CITY OF MERCER ISLAND

STAFF REPORT

SHORELINE SUBSTANTIAL DEVELOPMENT PERMIT

Project No.:	SHL22-019
Description:	A request for a Shoreline Substantial Development Permit with SEPA Review to demolish an existing shared pier, remove (23) existing piles, relocate (7) existing boatlifts, relocate one existing dual jet ski lift, install (2) new dual jet ski lifts, install one new personal watercraft (PWC) lift, removed one existing dock mounted PWC lift, drive (30) 8-inch steel piles, (12) 12-inch steel piles, install one platform lift, and construct a new 1106 sq ft dock with grated decking.
Applicant / Owner:	Dray Davick (Seaborn Pile Driving Co.) / Charles Jemley (signing member for community dock)
Site Address:	770X SE 58th St, Mercer Island, WA 98040; King County Assessor tax parcel number 294890TRCT.
Zoning District:	Single Family Residential (R-8.4)
Staff Contact:	Molly McGuire, Planner
Exhibits:	<ol style="list-style-type: none">1. Development Application, received by the City of Mercer Island on September 1, 20222. Revised Development Plan Set, dated February 21, 2023 and received April 24, 20233. Project Narrative, received September 1, 20224. SEPA Checklist, received Septem

SHEET
A5.0

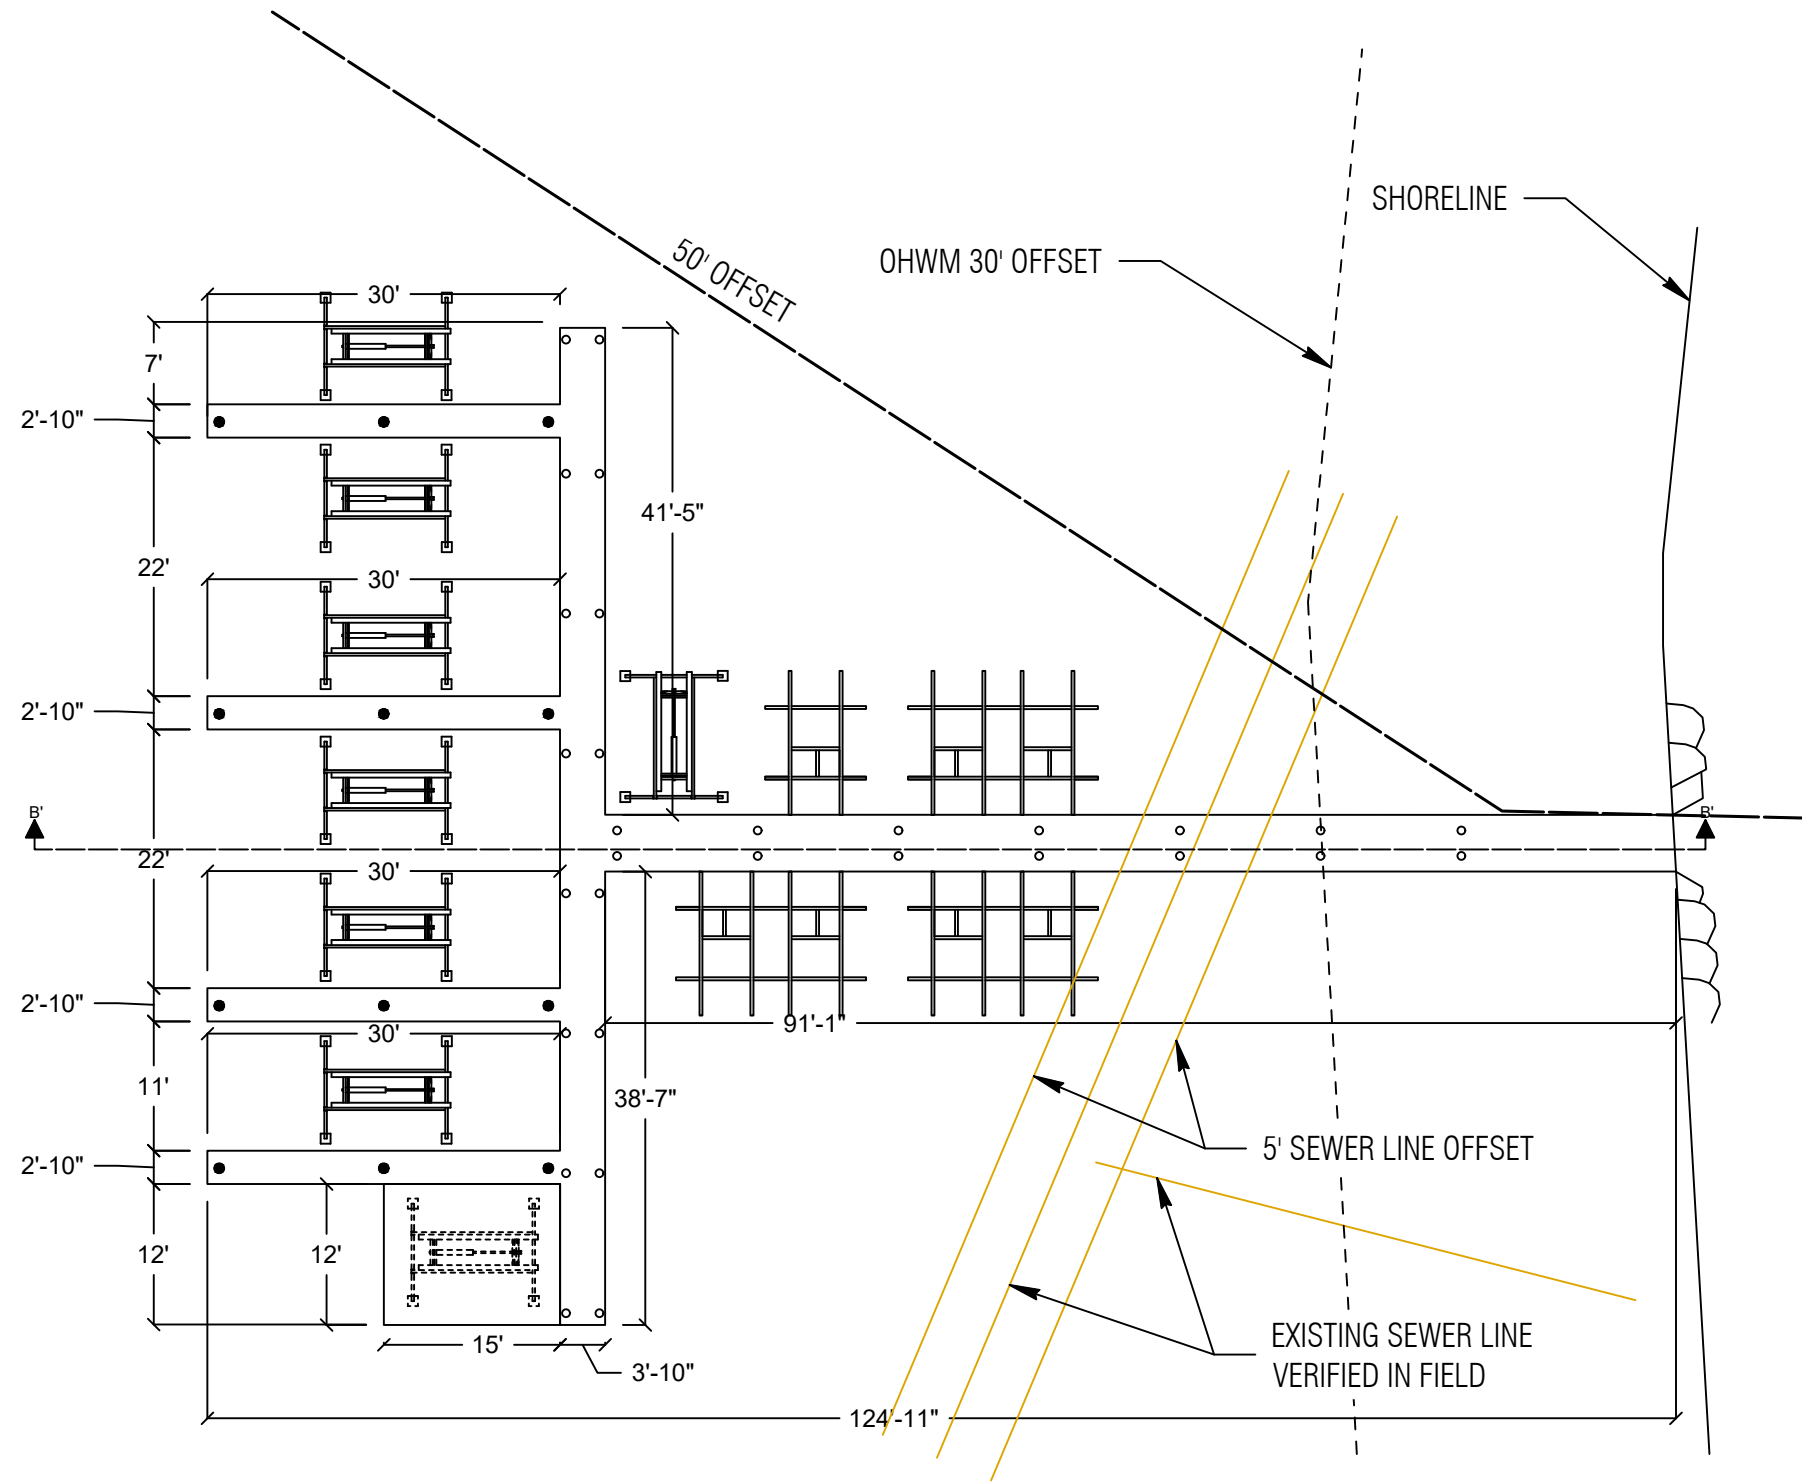
Staff Analysis: The proposed moorage facility is greater than 10 feet from the lateral line at the south lateral line sharing a common boundary with a residential property (**Exhibit 2, Sheet A3.0**); therefore, this requirement is met.

Staff Analysis: The proposed moorage facility is greater than 50 feet from the lateral line at the north lateral line sharing a common boundary with the urban park environment (**Exhibit 2, Sheet A3.0**); therefore, this requirement is met.

Staff Analysis: The proposed moorage facility would be 4 feet 10 inches wide within 30 feet waterward of the OHWM (**Exhibit 2, Sheet A3.0**). The applicant has provided documentation that a resident of a property utilizing the semi-private recreational tract has a documented permanent state disability as defined in WAC308-96B-010(5) (**Exhibit 6**); therefore, the proposed dock width meets this requirement.

Staff Analysis: The proposed moorage facility would not be greater than 6 feet wide more than 30 feet waterward from the OHWM (**Exhibit 2, Sheet A3.0**).

Staff Analysis: The subject tract has a water frontage of 125 feet (**Exhibit 2, Sheet A3.0**); therefore, this requirement is met.

SHEET
A7.0

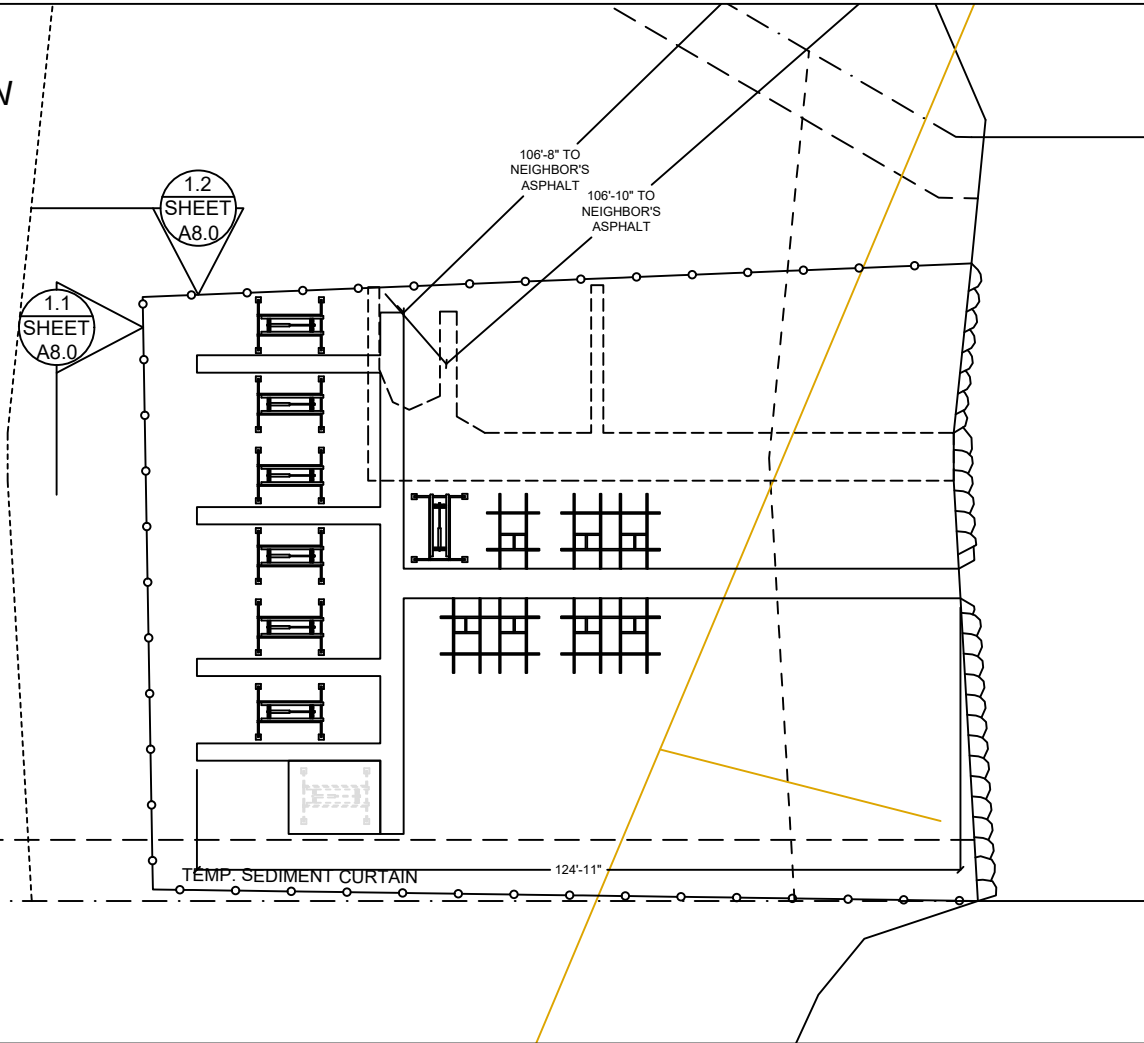
Staff Analysis: The proposed moorage facility extends 124 feet 11 inches waterward from the OHWM to a water depth of 11.85 feet (**Exhibit 2, Sheet A7.0**); therefore, this requirement is met.

2. Sheet A7.0 of the plan set shows the water depths for the proposed project. Please show where the water depth is 11.85', and that the proposed dock is within that allowed water depth.

**SHEET
A15.0**

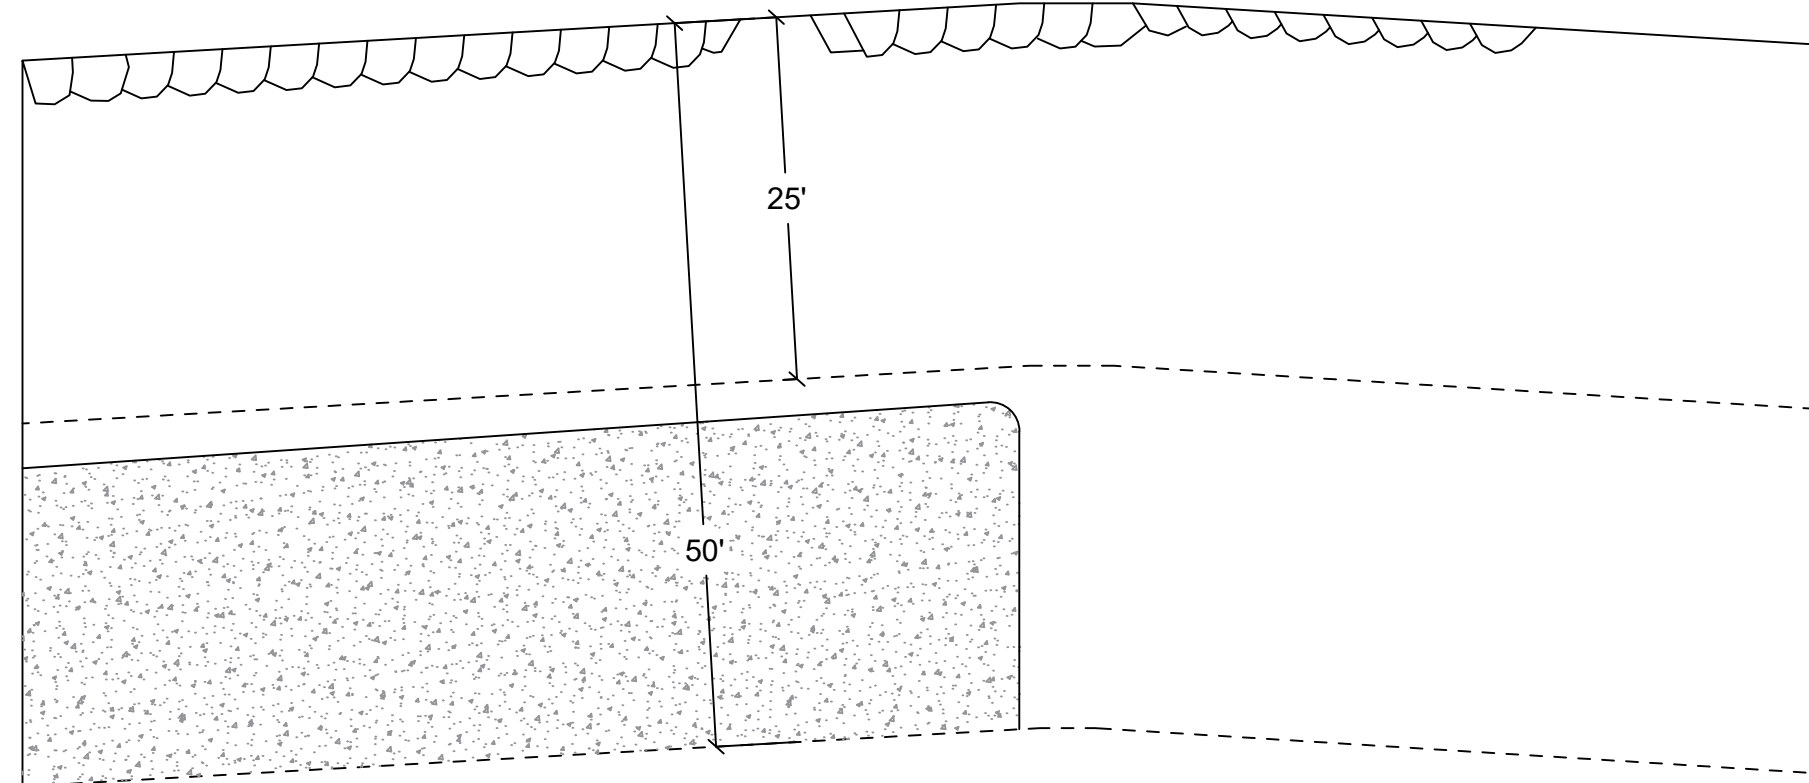
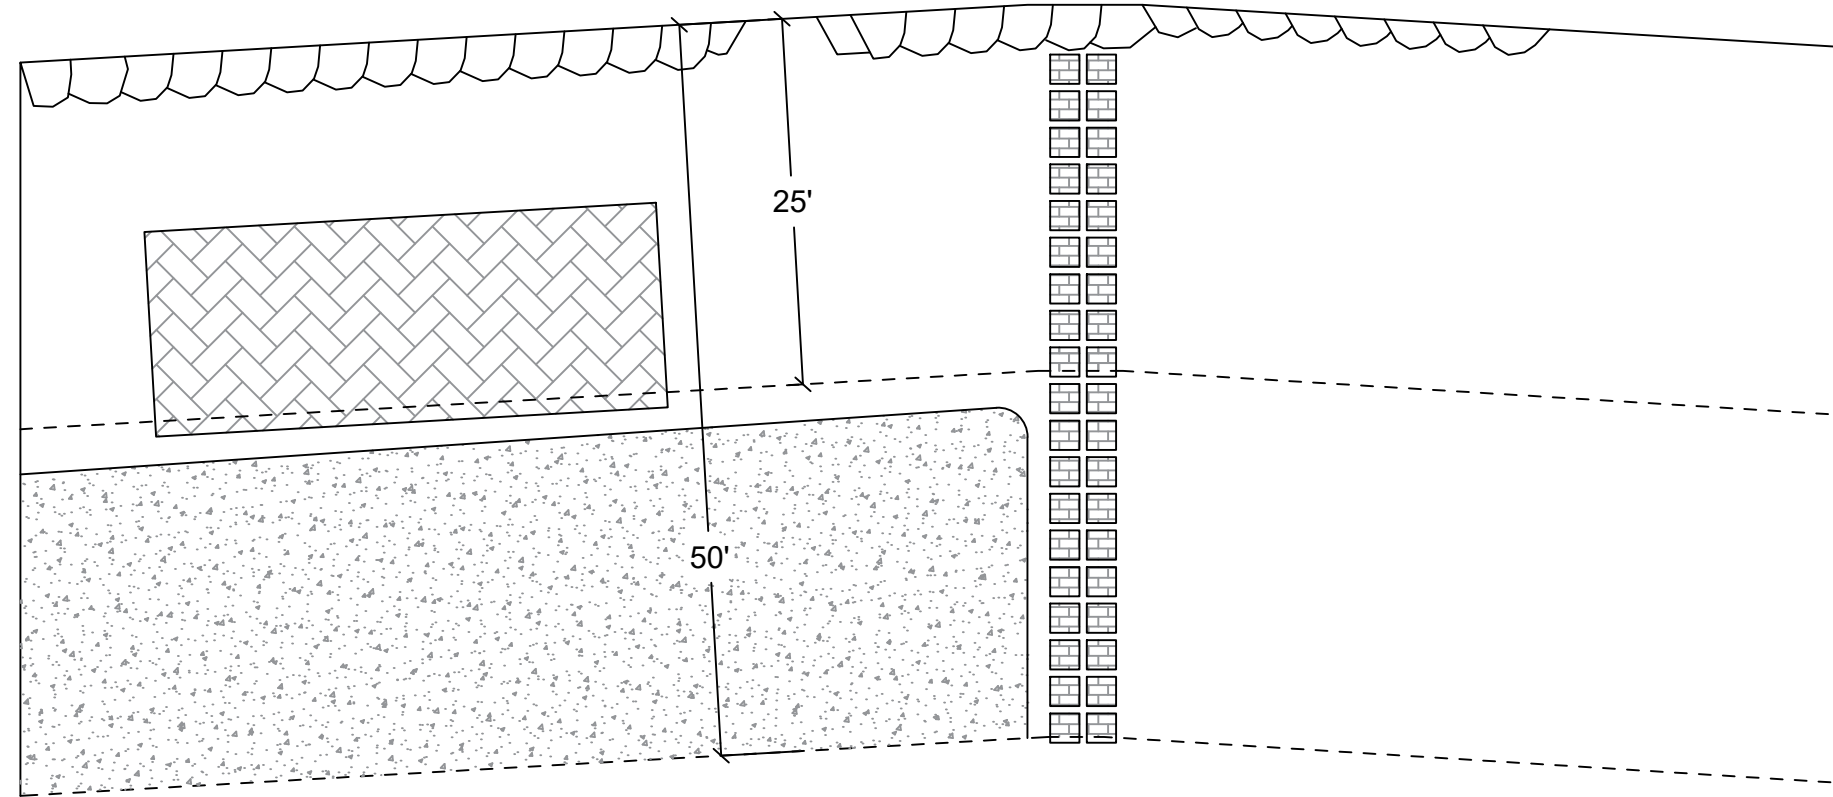
Staff Analysis: The proposal does not include structures within 25 feet from the OHWM. The existing parking area is located greater than 25 feet from the OHWM (**Exhibit 2, Sheet A15.0**); therefore, this requirement is met.

The proposal results in 7.6 percent of hardscape within 0-25 feet from the OHWM and 49 percent of hardscape and lot coverage within 25-50 feet from the OHWM due to the legally nonconforming parking area (**Exhibit 2, Sheet A15.0**); therefore, this requirement is not met and allowed to continue.
